Front Suspension – Knocks –
New “V” Mount Introduced

MODEL 1995 MY
Sedan Range

VIN
720001 - 722757

ILLUSTRATION 1

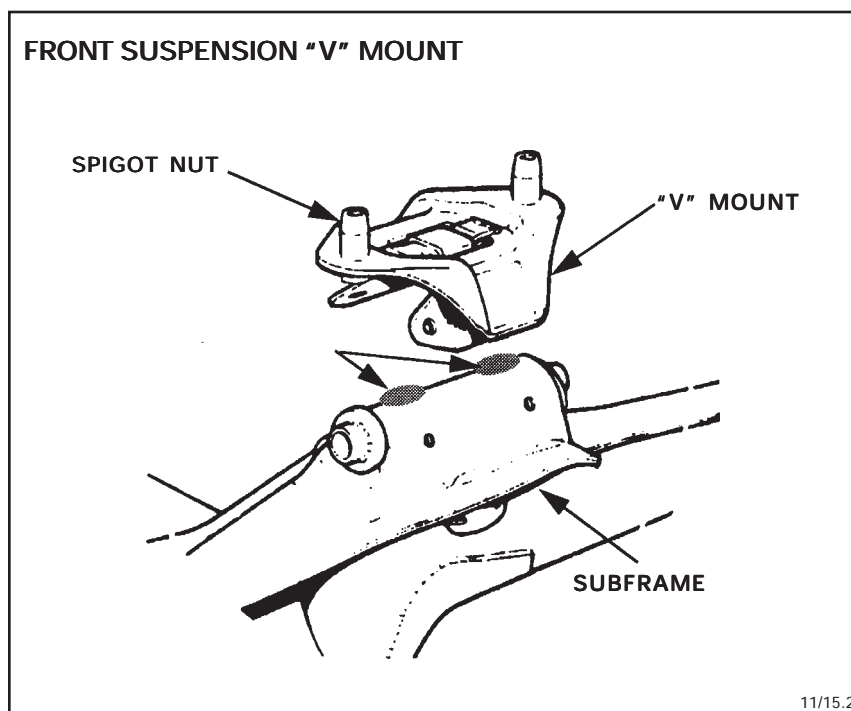
Knocks or rattles from the front suspension of 1995 MY Sedan Range vehicles within the above VIN range may be caused by the front suspension “V” mount spigot nuts contacting the front subframe (crossbeam). A new “V” mount with shorter spigot nuts was introduced in production at VIN 722758.

If a customer complains of a hard knock from the front suspension of a 1995 MY Sedan Range vehicle within the above VIN range when driving over a rough road surface, check for evidence of contact between the front suspension “V” mount spigot nuts and the front suspension subframe (Illustration 1). If contact is found, replace the existing front suspension “V” mounts with new “V” mounts (part number MNA 2360AD) as follows:
